SUBJECT: SUSQUEHANNA STEAM ELECTRIC STATION, UNITS 1 AND 2 - STAFF ASSESSMENT OF INFORMATION PROVIDED PURSUANT TO TITLE 10 OF THE *CODE OF FEDERAL REGULATIONS* PART 50, SECTION 50.54(f), SEISMIC HAZARD REEVALUATIONS FOR RECOMMENDATION 2.1 OF THE NEAR-TERM TASK FORCE REVIEW OF INSIGHTS FROM THE FUKUSHIMA DAI-ICHI ACCIDENT (CAC NOS. MF3707 AND MF3708)

STAFF ASSESSMENT BY THE OFFICE OF NUCLEAR REACTOR REGULATION
RELATED TO SEISMIC HAZARD AND SCREENING REPORT
SUSQUEHANNA STEAM ELECTRIC STATION, UNITS 1 AND 2
DOCKET NOS. 50-387 AND 50-388

Figure 3.3-1 Plot of Staff's and Licensee's Base Case Shear-Wave Velocity Profiles for the SSES Site

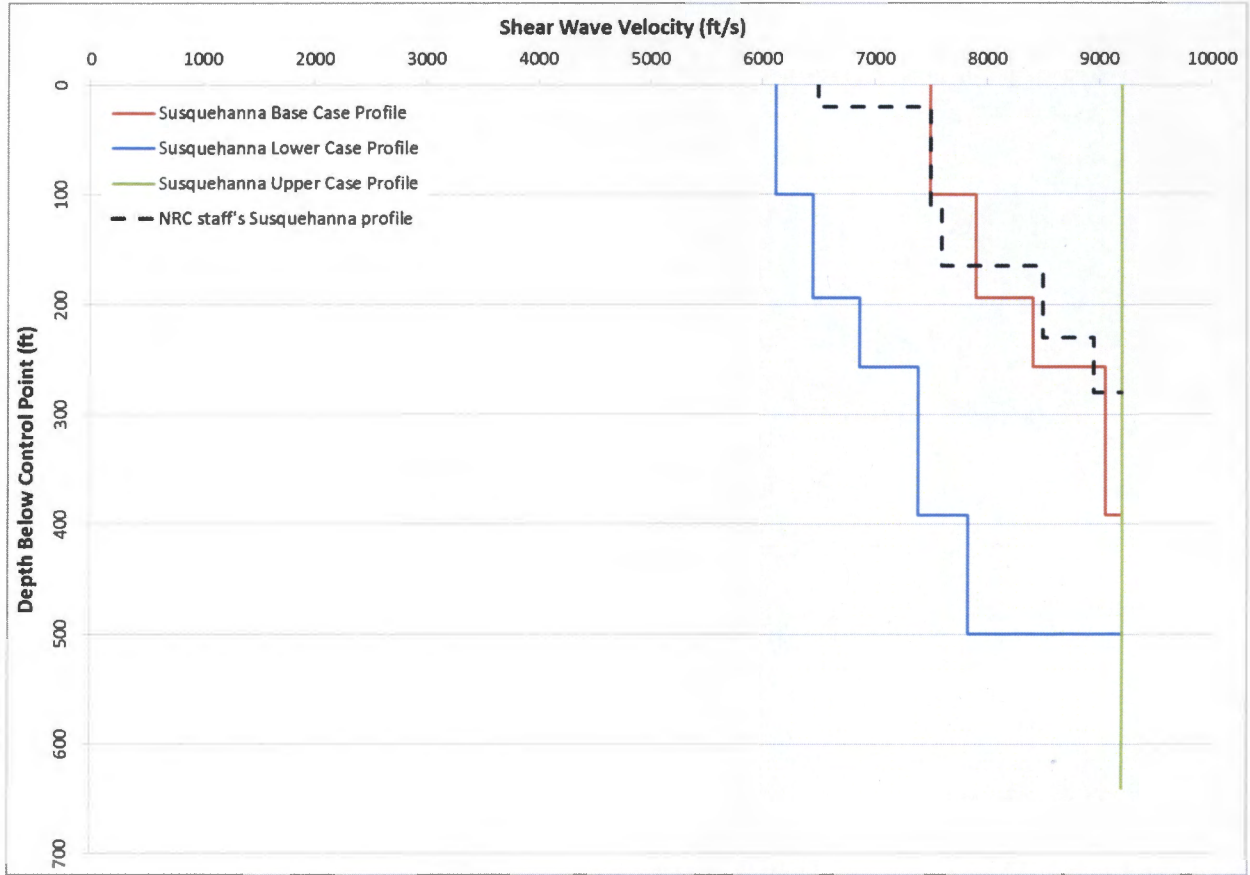
velocity profile for each of the three base cases. Figure 3.3-1 of this assessment shows the licensee's three shear-wave velocity base case profiles.

Because of the high quality of the data and the geologic consistency between the SSES and BBNPP sites, the staff's base case shear-wave velocity is based on measured shear-wave velocity data reported in the SSES UFSAR (PPL, 2011) and the BBNPP FSAR (Unistar, 2013). In addition, due to the consistencies between the SSES and BBNPP sites, the NRC staff used a single base case velocity profile rather than the three profiles developed by the licensee. Figure 3.3-1 of this assessment shows the NRC staff velocity profile compared to the base case profiles developed by the licensee.

Figure 3.3- 2 Plot Comparing the Staff's and the Licensee's Median Amplification Functions and Uncertainties for the SSES site.

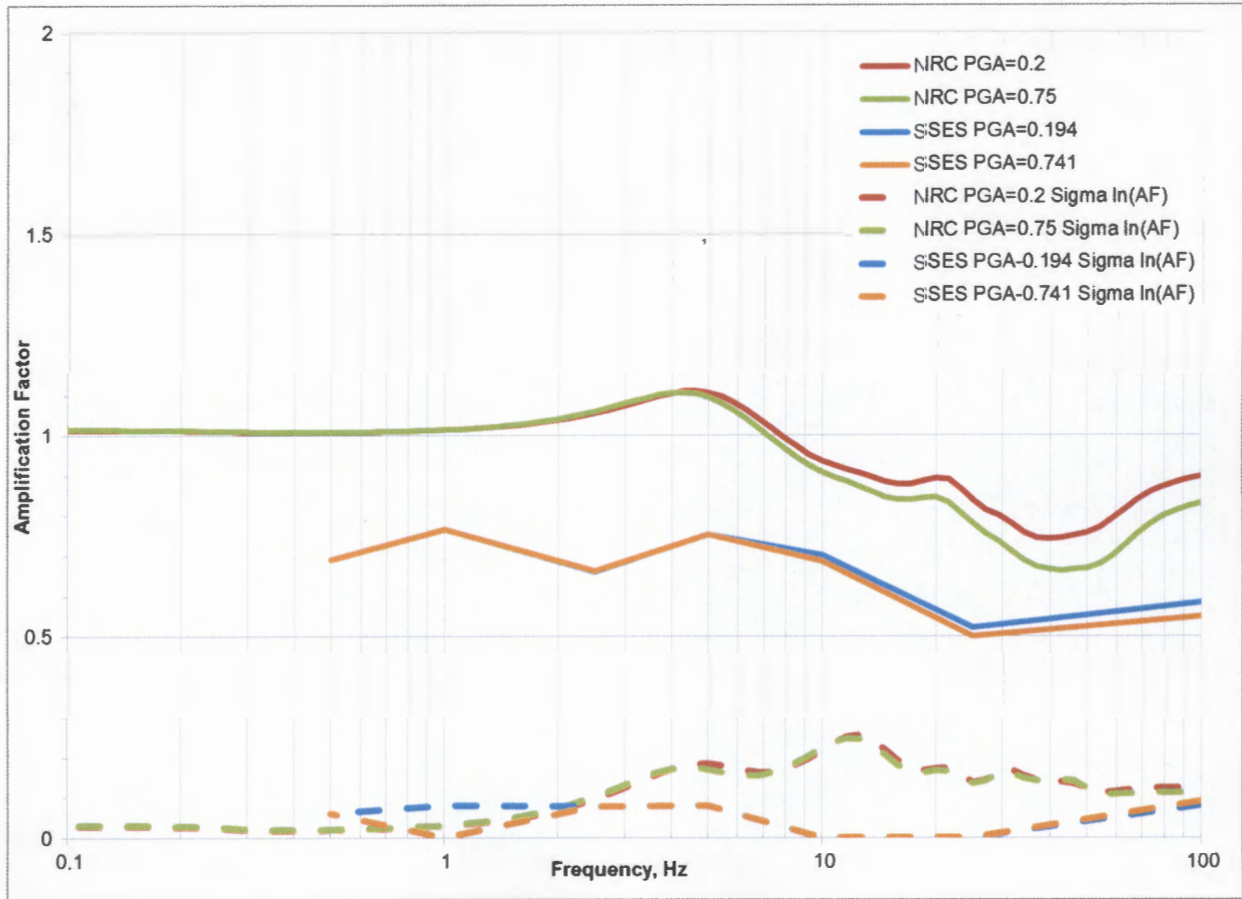
Figure 3.3-2 of this assessment shows a comparison of the staff's and licensee's median site amplification factors and uncertainties (± 1 standard deviation) for 2 of the 11 input loading levels. The staff's median site amplification factors are larger than the licensee's. Differences in site amplification curves developed by the NRC staff and the licensee are due to differences in site base case profiles and kappa values. However, these differences in the site amplification curves do not result in large difference in the control point hazard curves, or the GMRS, as described below.

Figure 3.3-3 Plot Comparing the Staff's and the Licensee's Mean Control Point Hazard Curves at a Variety of Frequencies for the SSES site

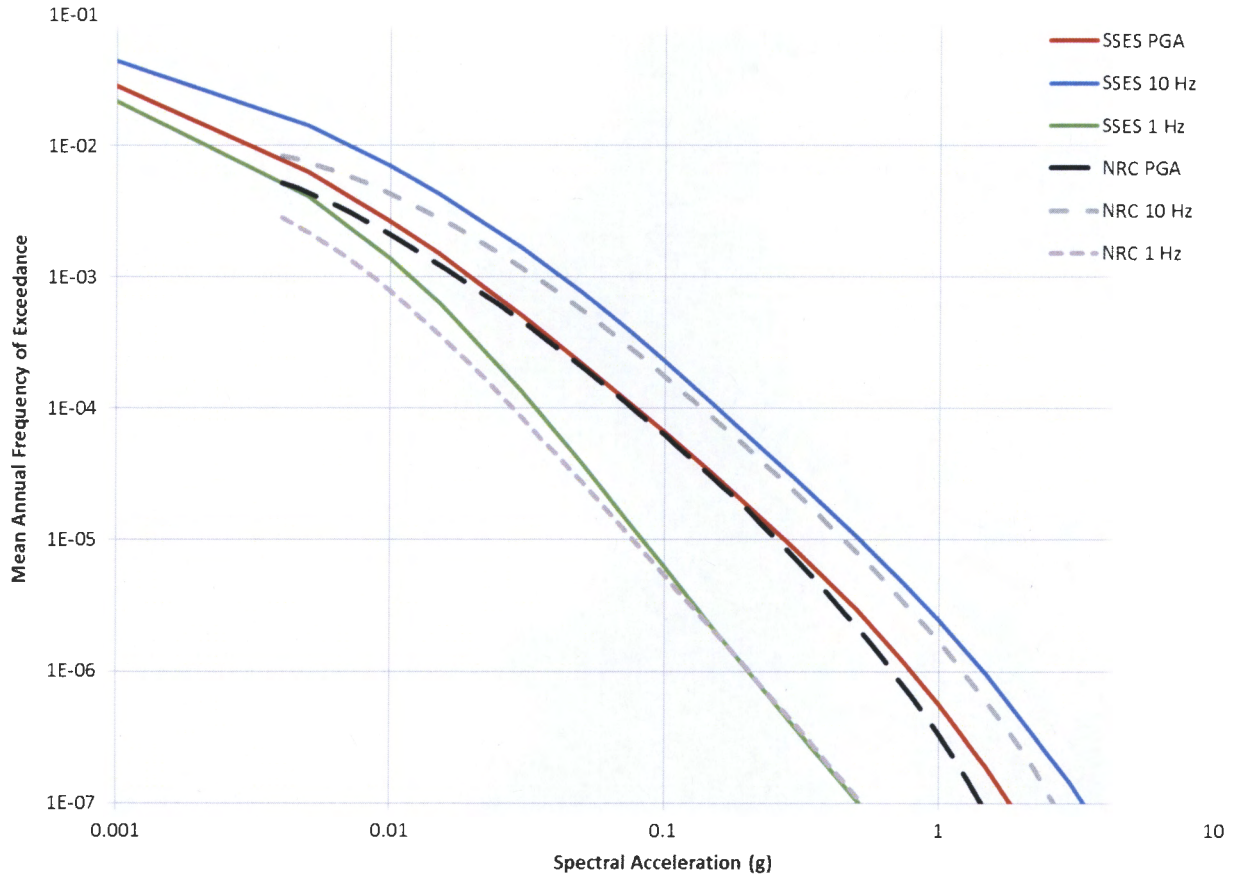
Figure 3.3-3 of this assessment shows a comparison of the licensee's and staff's control point hazard curves. The staff's median site amplification factors are similar to the licensee's and Figure 3.3-3 of this assessment figure shows that the differences in site amplification curves had only a minor impact on the control point seismic hazard curves. Appendix B of the SPID provides guidance for performing site response analyses, including capturing the uncertainty for sites with less subsurface data; however, the guidance is neither entirely prescriptive nor comprehensive. As such, various approaches in performing site response analyses, including the modeling of uncertainty, are acceptable for the 50.54(f) response. In summary, the NRC staff concludes that the licensee's site response was conducted using present-day guidance and methodology, including the NRC-endorsed SPID. The NRC staff performed independent calculations which confirmed that the licensee's amplification factors

and control point hazard curves adequately characterize the site response, including the uncertainty associated with the subsurface material properties, for the SSES site.

Figure 3.4-1 Comparison of the Staff's GMRS with Licensee's GMRS and the SSE for the SSES site

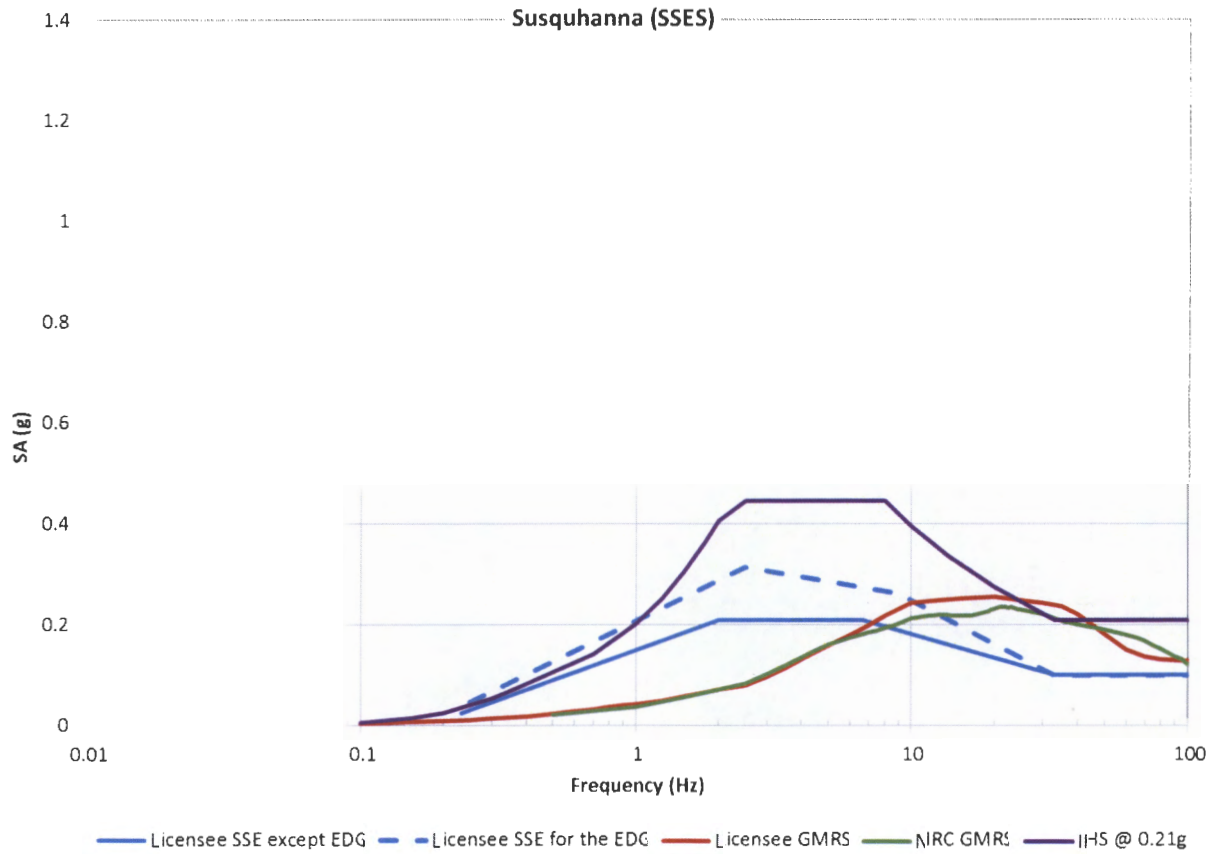
The NRC staff independently calculated the 10^{-4} and 10^{-5} UHRS using the results of its confirmatory PSHA and site response analysis, as described in Sections 3.2 and 3.3 of this NRC staff assessment, respectively. Figure 3.4-1 of this assessment shows a comparison of the GMRS determined by the licensee to that determined by the NRC staff. As shown in Figure 3.4-1, the licensee's GMRS shape is generally similar to that calculated by the NRC staff. The minor differences in the licensee's and staff's GMRS result from the differences in the site response analyses, as discussed in Section 3.3 above.

The NRC staff confirms that the licensee used the present-day guidance and methodology outlined in RG 1.208 and the SPID to calculate the horizontal GMRS, as requested in the 50.54(f) letter. The NRC staff performed both a PSHA and site response confirmatory analysis and achieved results consistent with the licensee's horizontal GMRS. As such, the NRC staff concludes that the GMRS determined by the licensee adequately characterizes the reevaluated hazard for the SSES site. Therefore, this GMRS is suitable for use in subsequent evaluations and confirmations, as needed, for the licensee's response to the 50.54(f) letter.
